Response to NRC Queries of October 28, 1976 for the
Uranium Mill of Atlas Minerals Division of the
Atlas Corporation at Moab, Utah

NRC Ref: FCPF:PAS
40-3453
SUA-917

RESPONSE TO NUCLEAR REGULATORY COMMISSION
QUESTIONS OF OCTOBER 28, 1976
ON ATLAS MINERALS ENVIRONMENTAL REPORT
LICENSE NO. SUA-917

PLAN SHOWING GROUND WATER / SURFACE
WATER RELATIONSHIPS TO THE MOAB
MARSH SUMP.

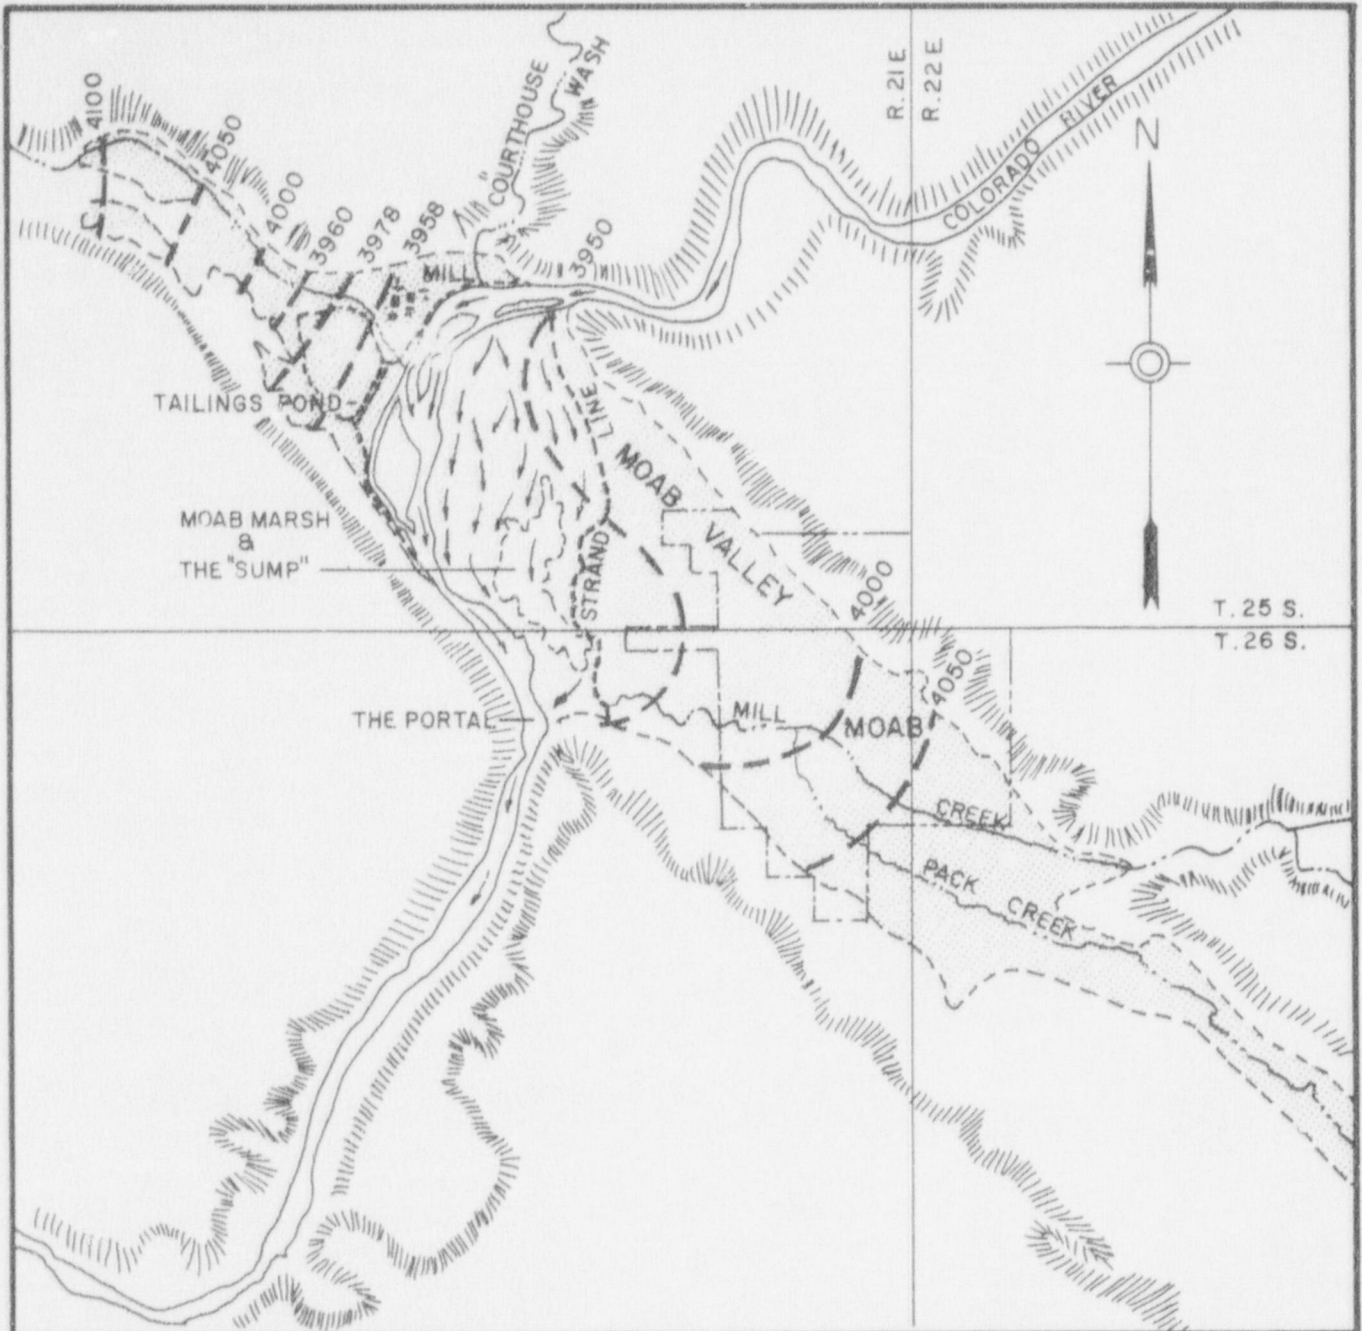
Provide water quality analyses for the water from the "sump" in Moab Marsh (p.2-22).

Provide computation of the probable maximum flood including the probable flow patterns across Moab Marsh, and maximum flow velocity along the tailings dike. Explain why the flood mentioned in the ER (ER Supp. p. 17) is level with the toe of the embankment enclosing the tailings pond, while the same flood in the PSAR(sic) (PSAR(sic) p. 2.3-27) is 6.9 feet higher.

Query Nos. 2, 3 and 4 are related to the description of a "sump" located on the floodplane of the Colorado River, as presented on Page 2-22 of the Environmental Report(ER). In order to respond meaningfully, it is best to provide a discussion of the geomorphological relationships with the surface and groundwater regimes.

The meander path of the Colorado River is controlled by the change in gradient from the incised canyon east of the bridge crossing of U.S. Highway to a flatter gradient across the Moab Valley and by the constriction formed by the deeply incised "The Portal" on the western side of Moab Valley where the gradient of the river again increases and enters another deeply incised canyon. These conditions are shown on Figure 1.

Examination of Figure 1 reveals that the principal ground water recharge of the flood plane is from the Colorado River. This is augmented from the southeast by recharge associated with the flow of Mill Creek.

The requested flow lines of the Colorado River during flood stage are shown on Figure 1 prepared for Query No. 2.

FIGURE 2
SITE PLAN

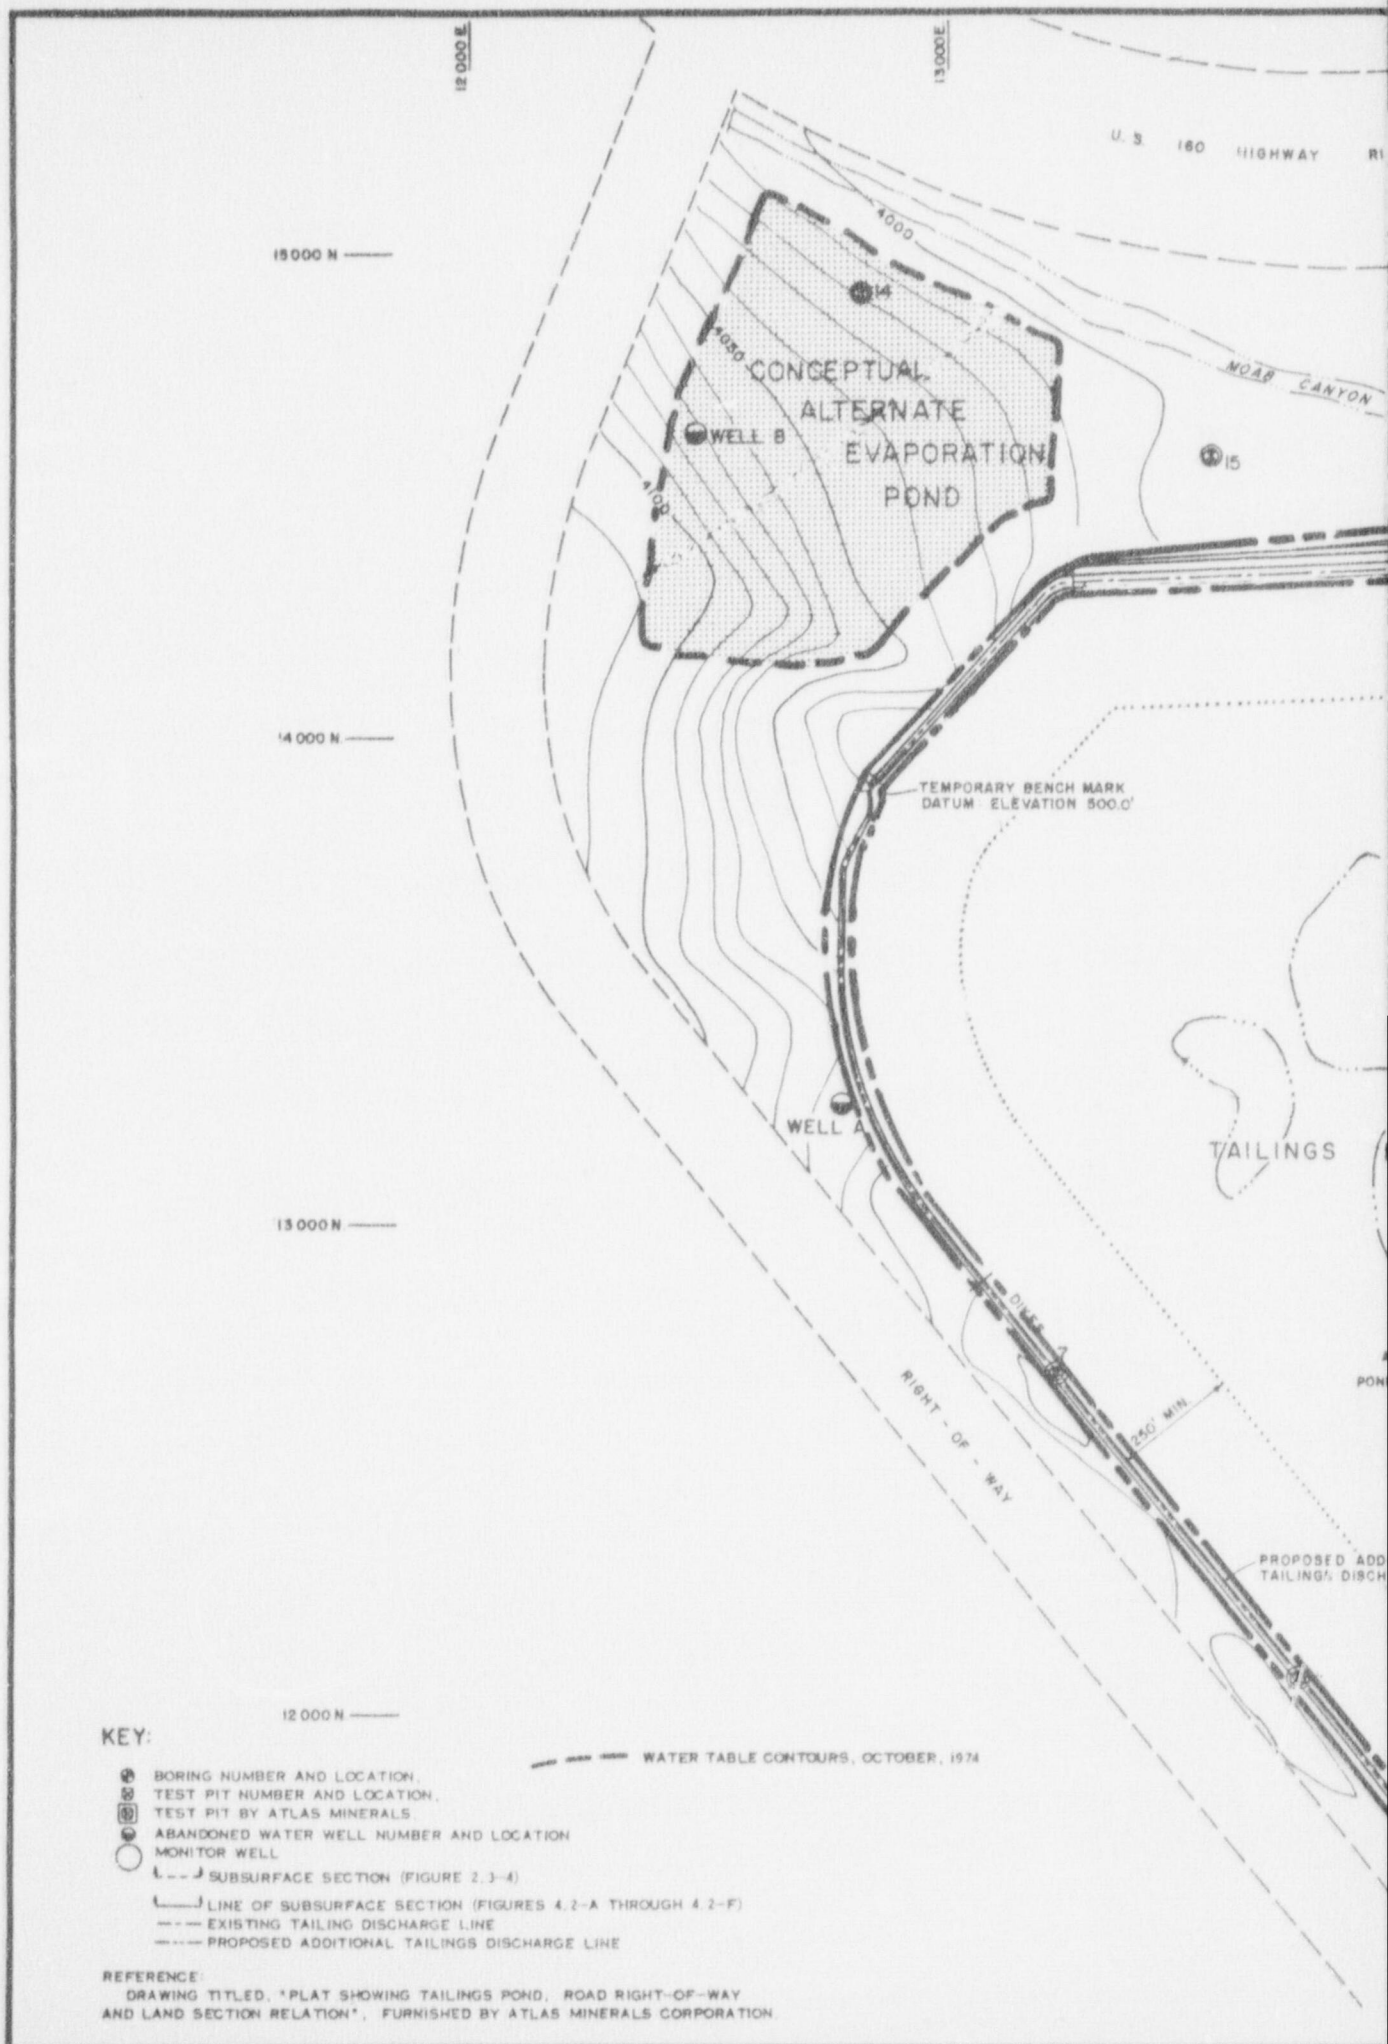
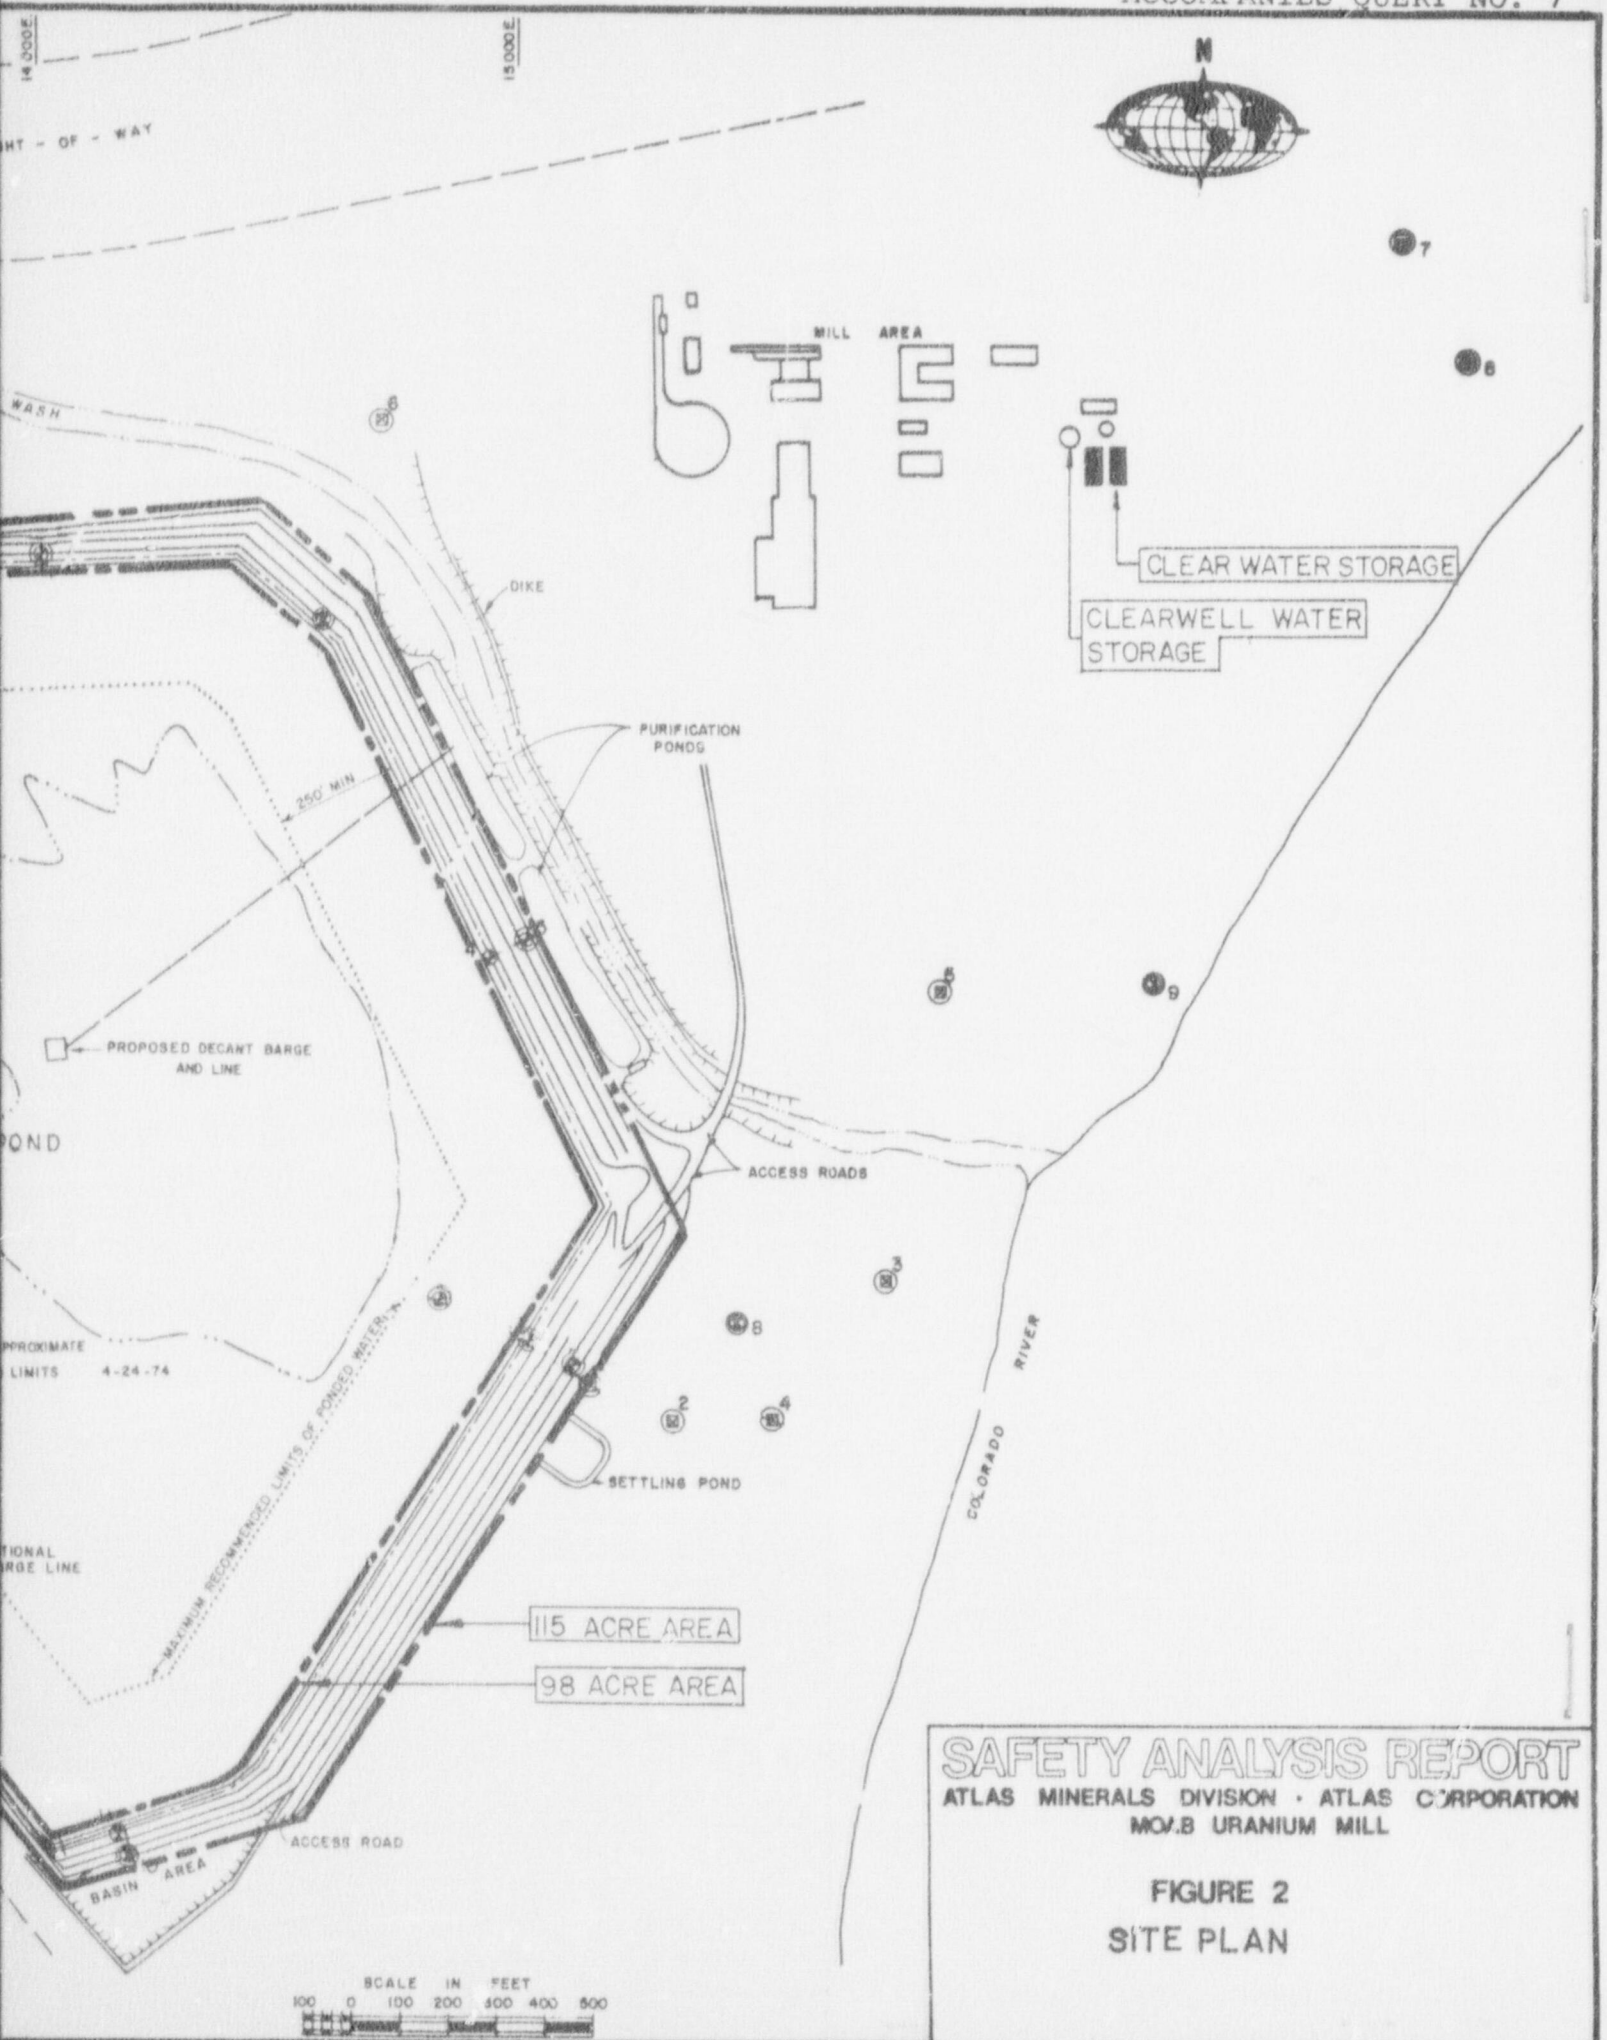
Show location on a map of the site where "an alternate evaporation pond" can be constructed (ER Suppl. p. 11).

Show location of the clear water storage pond and clearwell storage relative to the tailings pond (add to Fig. 3.5) (p.3-19).

Should the projected alternative evaporation pond prove to be needed, it is now considered that the best available site lies north of the existing tailings pond and west of Moab Wash. The site tentatively occupies 20 acres and is now under preliminary engineering design. The projected site is shown on accompanying Figure 2.

The geographical relationship of the clear water storage pond and clearwater storage to the tailings pond are shown on Figure 2 - Site plan, which accompanies Response to Query No. 7 , herein.

a.) On Plate 2, the basal area of the tailings pond constitutes approximately 115 acres. This area is shown on Figure 2 which accompanies the response to Query No. 7 .

FIGURE NO. 6
APPROPRIATIONS OF GROUND AND
SURFACE WATERS NEAR THE ATLAS
MILL.

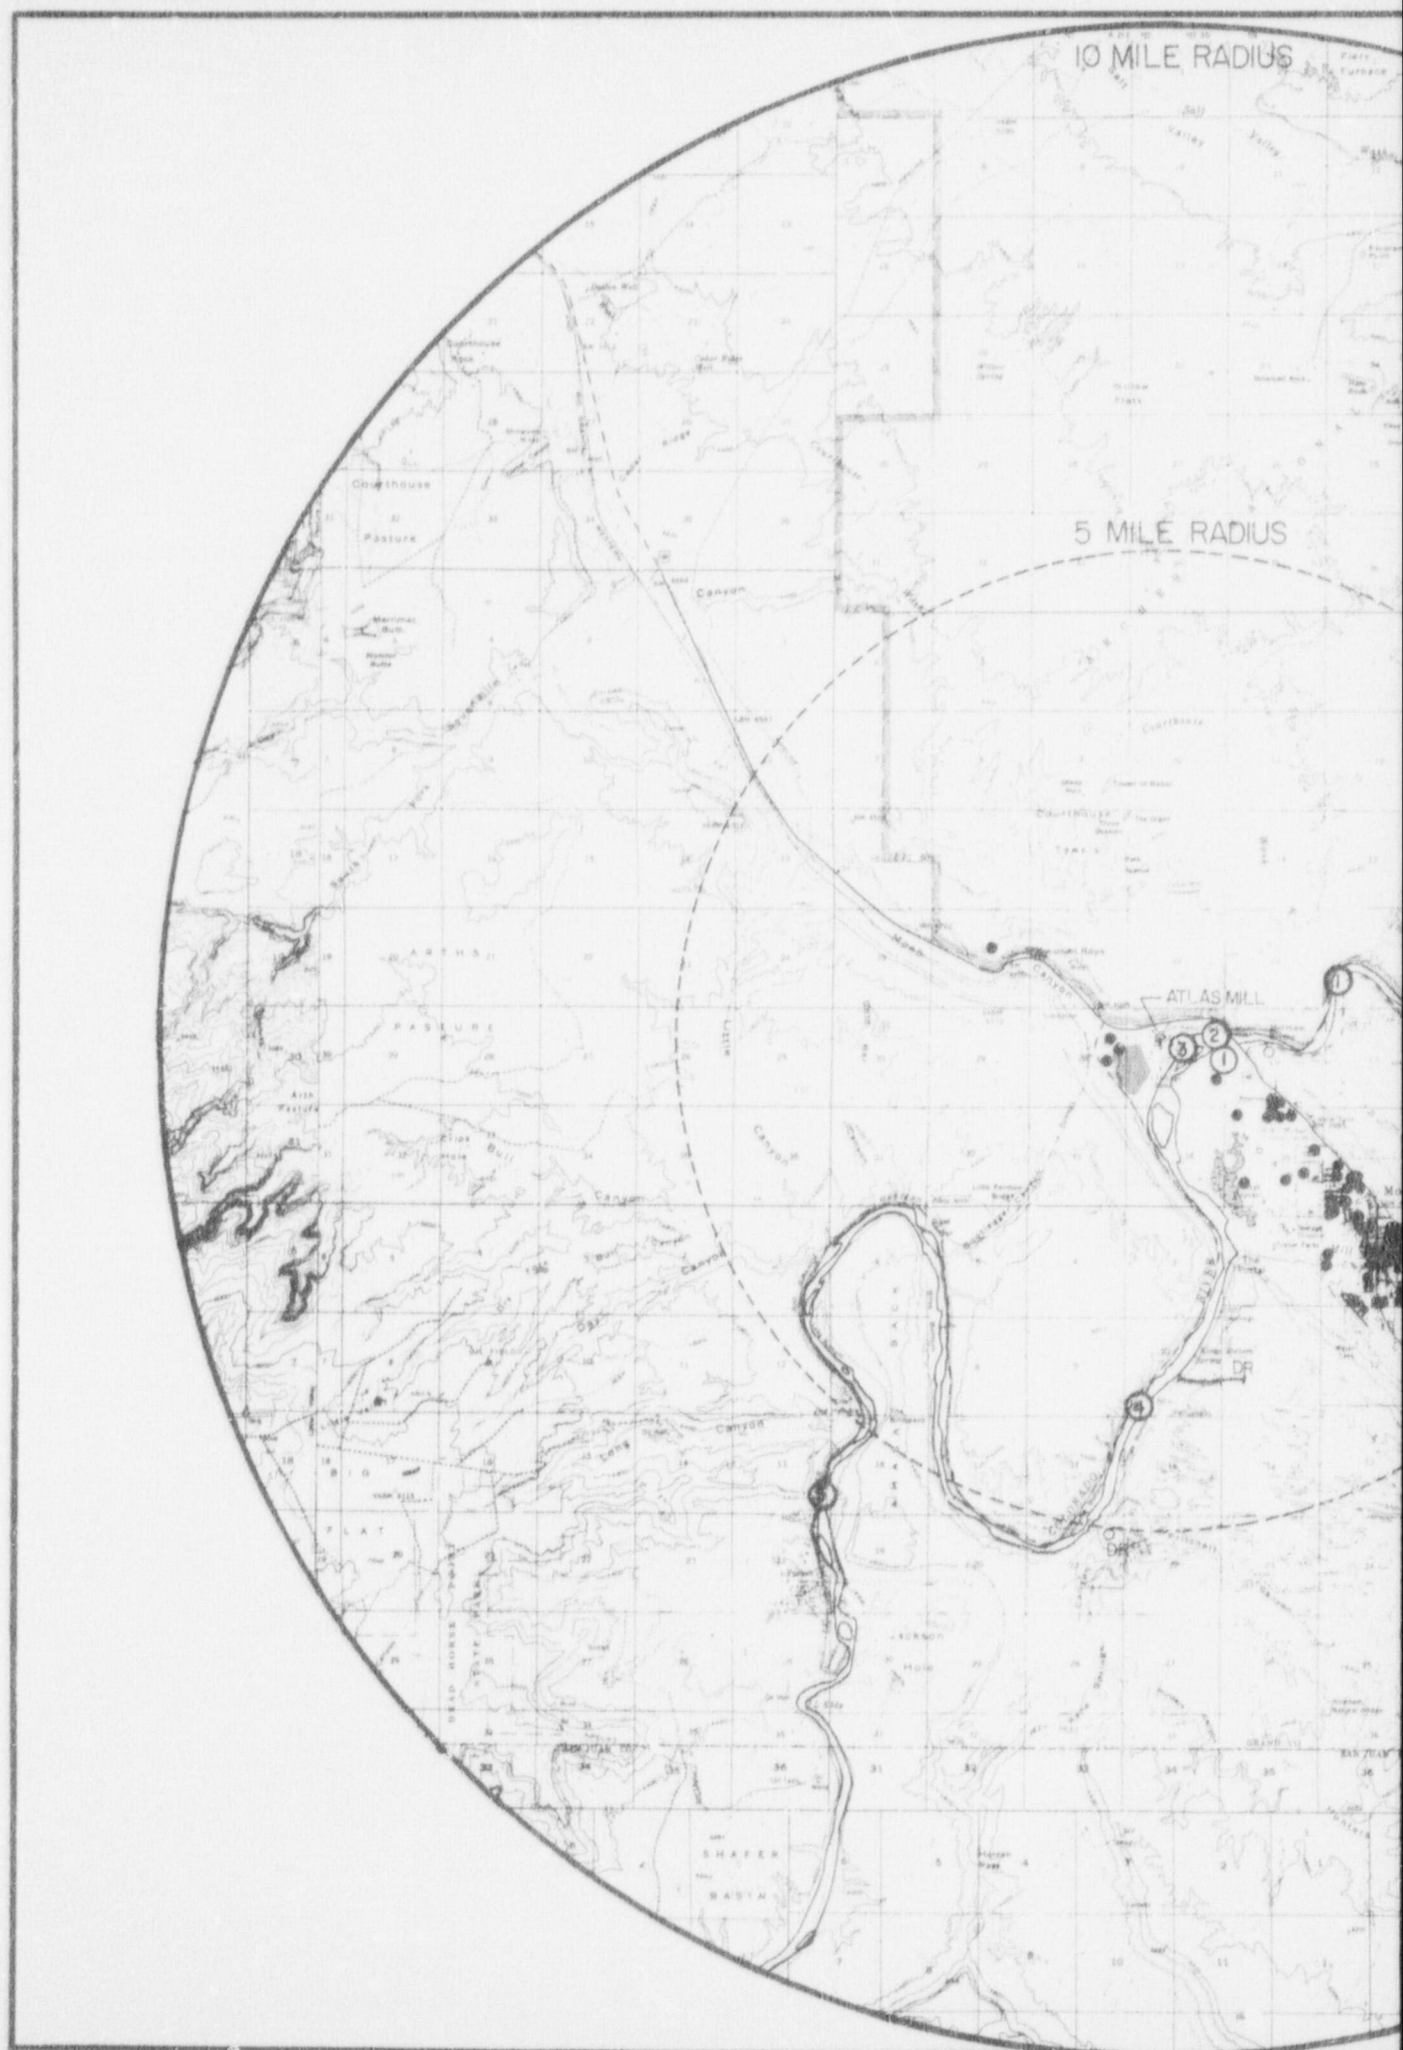
Provide the following details on surface and groundwater use in the vicinity of the site (Section 2):

b.) The points of withdrawal for the users of record for appropriation of both surface water and ground water are shown on accompanying Figure 6.
